LAKE HAVASU CITY, ARIZONA

ADDENDUM NO. 2
Police Department Fueling Facility
PROJECT NO.103005

Date Issued: August 12, 2022
Bid Date: August 24, 2021
To: All Planholders of Record

Attachment A
Police Department Fueling Facility
PROJECT NO.103005

UST REMOVAL SITE PLAN

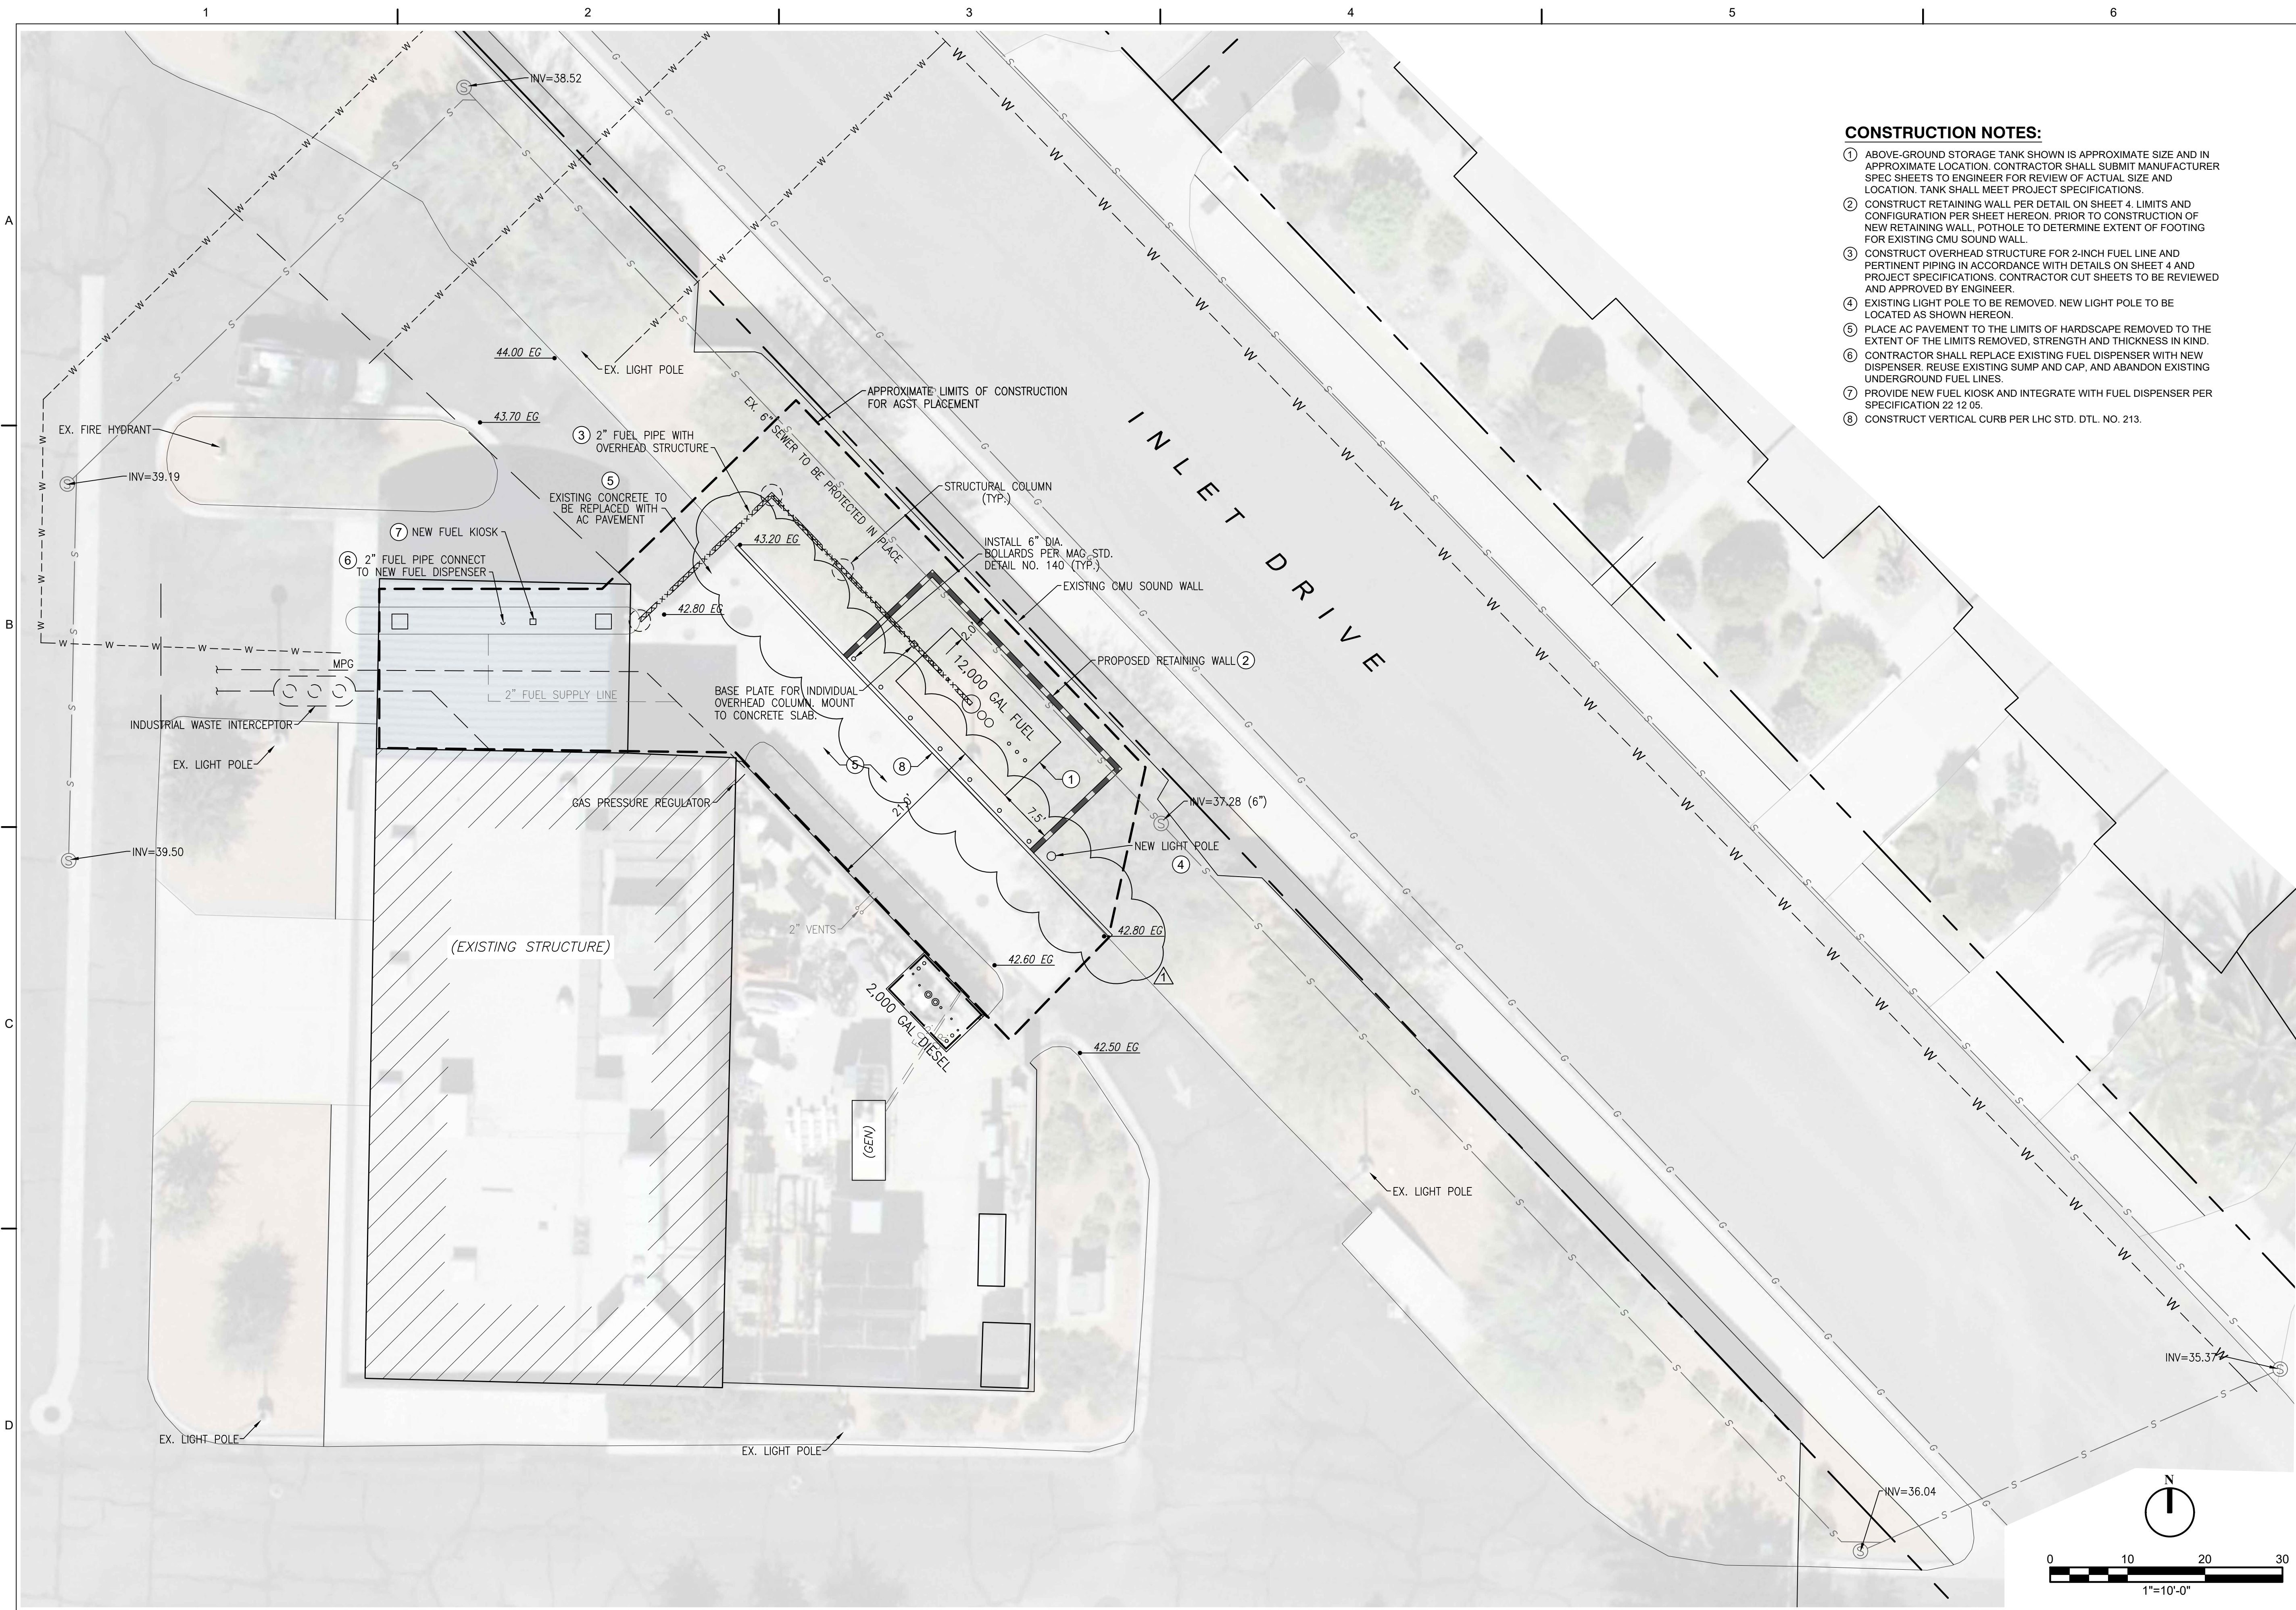
Item 3: Drawings C-2, C-3, and C-4 have been revised to:

1. Show an existing sewer line below the work area. Contractor to pothole and verify location and depth of the sewer line and the cleanout adjacent to the work area.
2. Better approximate the relative locations and slope of the existing sound wall and proposed retaining wall and tank slab.

DRAWING C-2

Question 3: According to note 1 the fuel system is to be removed within the limits of construction. Please confirm that the existing piping that extends beyond the construction limits is to be abandoned in place. If in fact it is to be abandoned in place please confirm if flushing and slurry filling of this pipe is necessary. Please also confirm that no removal of any existing piping is required beyond the shown construction limits.

Answer: The existing piping that extends beyond the construction limits is to be flushed and abandoned in place. No removal of existing piping is required beyond the shown construction limits.
